Re: HVO Continuation Project (SSD-11826681 and SSD-11826621) – response to Biodiversity and Conservation Division on flooding matters

HVO Continuation Project – Response to Torrent
Consulting and BCD in relation to flooding

RE: HVO CP Response to Flooding Peer Review and BCS

Figure 1: Comparison Points, HVO CP Flood Extent (Blue Outline) and Singleton Council Draft 1% (1:100) AEP Flood Map - Lemington

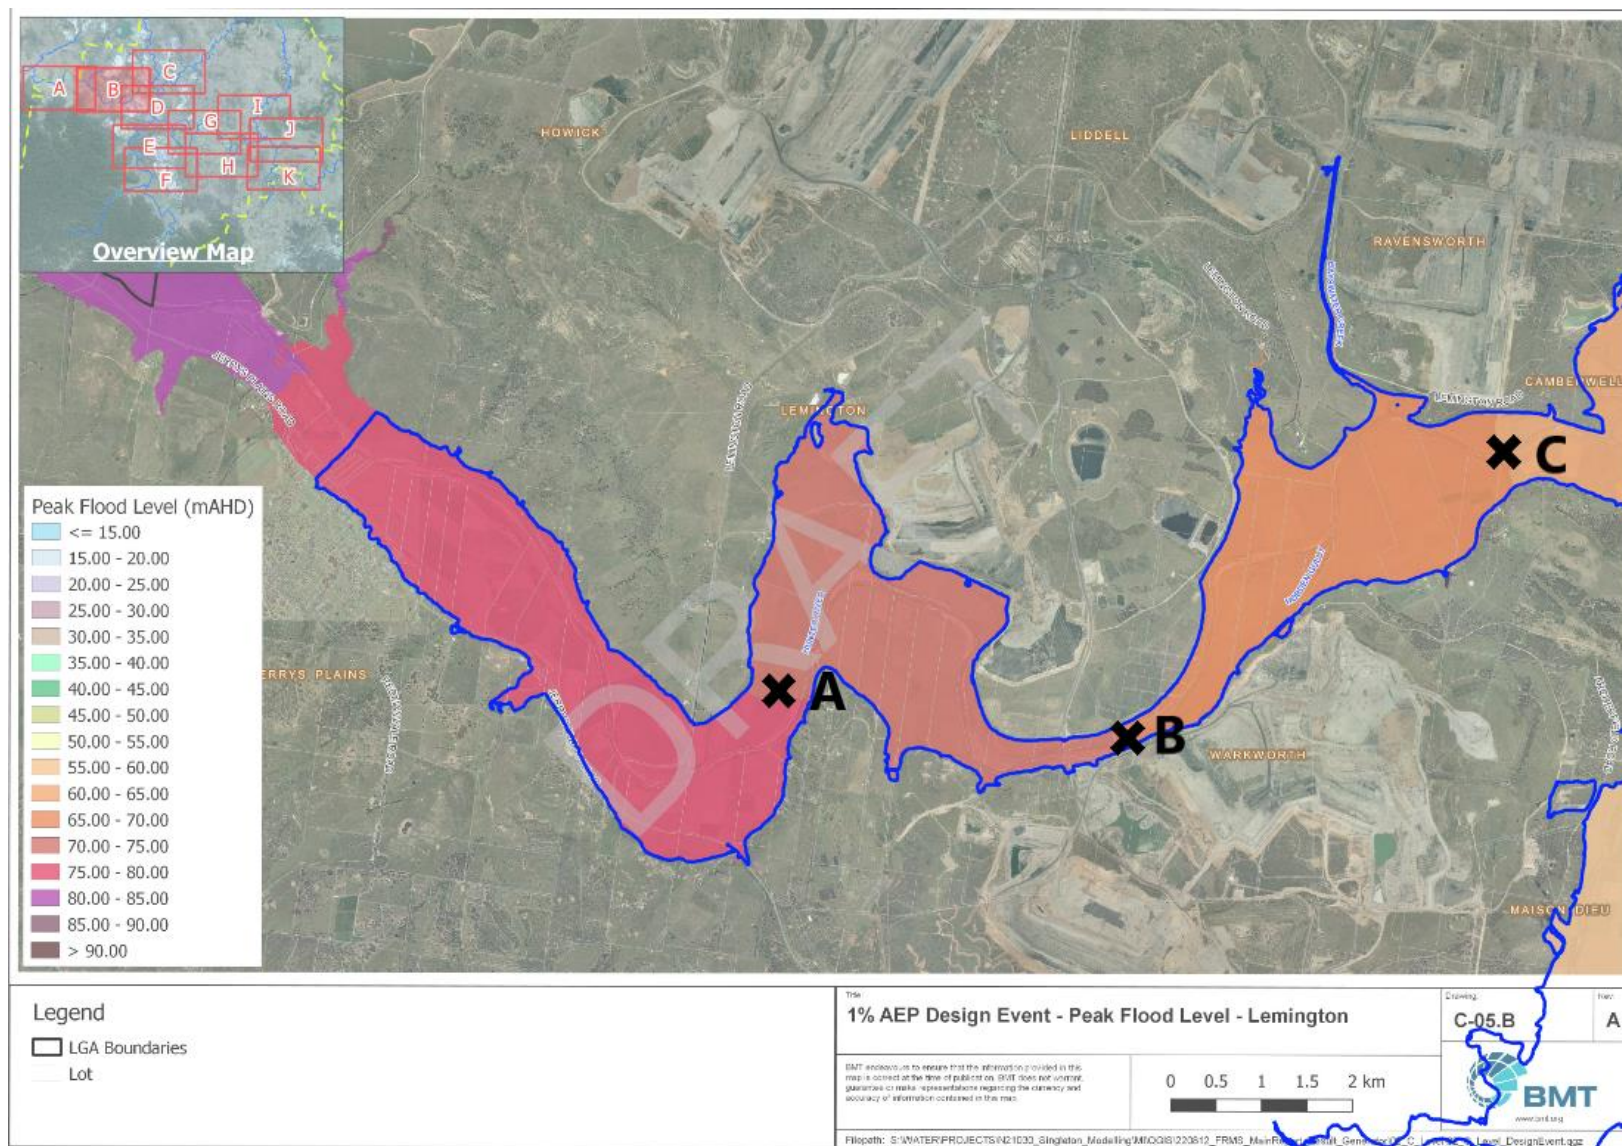
- The methodology employed for design inflow derivation potentially underestimates peak design flows at the upstream model boundary. This may provide for a lower peak flood condition in the upstream reach of the Hunter River between Liddell and the Glennies Creek confluence. The potential for higher design flows for a given flood magnitude may warrant consideration of potential impact on design flood immunity for proposed infrastructure. However, it is not expected that inflow refinement would change the overall findings of the impact assessment, being a relative condition. The potential variation in design flow may be considered by undertaking further sensitivity testing or reviewing change in flood condition with higher order events already established.*

While design flow estimates are lower for the HVO CP study compared to the Singleton Council flood study, the resulting flood levels for the HVO CP study are higher throughout the model domain (refer Table 2, Figure 1 and Figure 2). On further investigation, it is evident that this is due to the lower floodplain roughness value adopted in the Singleton Council flood study. Further adjustment of HVO CP design flood hydrographs should not be undertaken without consideration of other model parameters (e.g. Manning's roughness) and any calibration and/or validation undertaken.

We conclude that design flood level outcomes of the HVO CP study are more conservative relative to the Singleton Council flood study and are suitable for informing design levels and infrastructure immunity for the HVO CP. Furthermore, as noted by the peer review, "it is not expected that inflow refinement would change the overall findings of the impact assessment, being a relative condition".

Figure 3: Time of Inundation Comparison

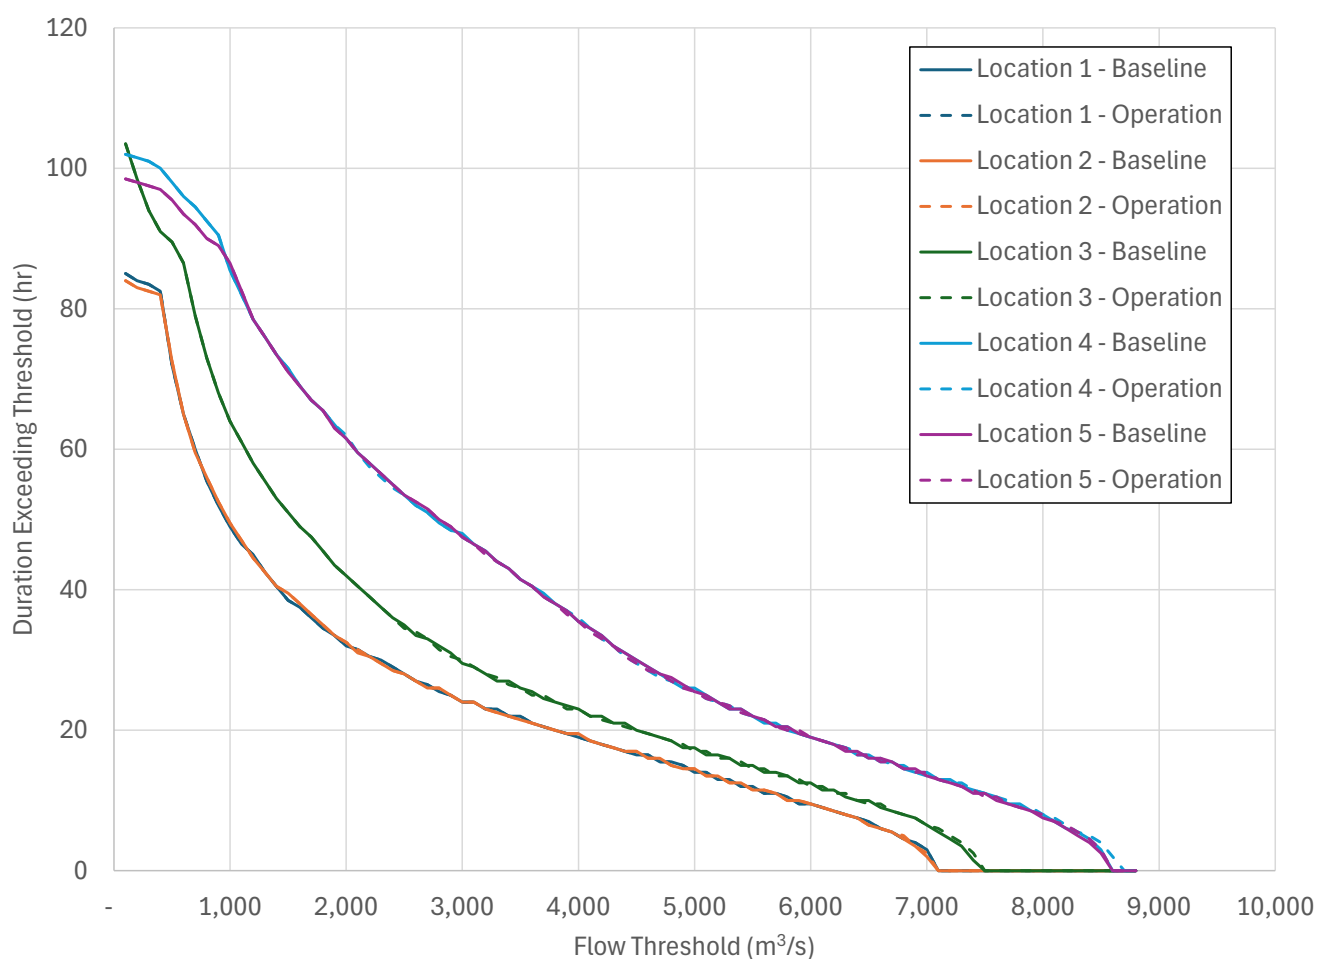
Recommendation 1: Produce mapping at an appropriate scale and resolution such that each landholder can clearly understand the estimated increase in flood levels, velocities and hazard as well as time of inundation.

- An assessment of the change in time of inundation has been undertaken by extracting flow hydrographs at discrete locations in the vicinity of the relevant properties. These have been extracted using the Plot Output (PO) functionality of TUFLOW and use a 0.5 hr reporting increment. The duration of flows above various thresholds has been extracted and compared for the Project Baseline and Project Operations scenarios. These results are summarised in Figure 3 for the locations shown in Figure 4 and indicate negligible change in the duration of flood flows (average change across all locations and flow thresholds is less than 1% while the maximum change is generally less than 5%). Consequently, it is evident that there is minimal change in time of inundation on these properties.
